# Technical Service Information

## THM 3T40 (125C) NEW FORWARD CLUTCH PISTON SEALS

Figure 1

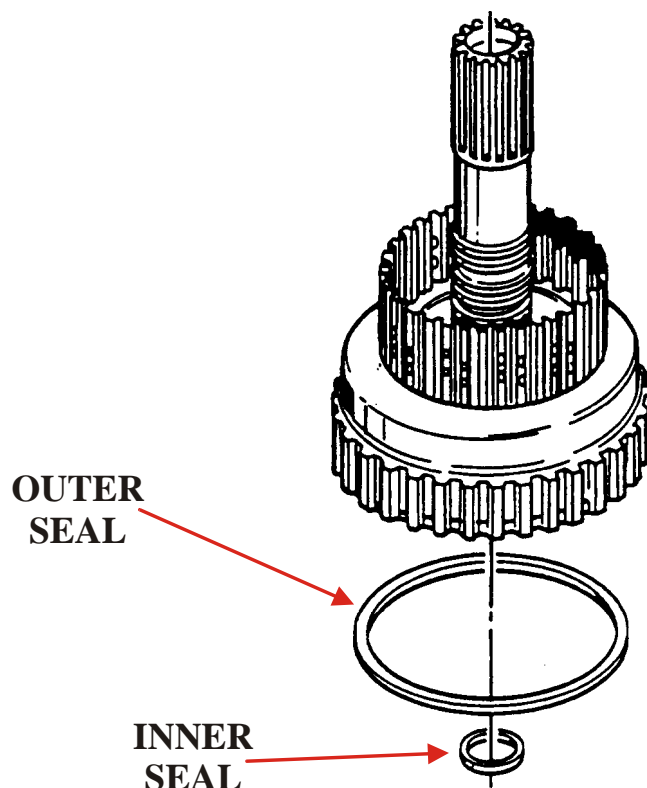
There are now new Forward Clutch Piston Seals available for the 125C (3T40), that are made of "Viton" which will withstand much more heat, before becoming brittle and taking a permanent heat set.

These new Forward Clutch Piston Seals are available in a service package, under OEM part number 8631986.
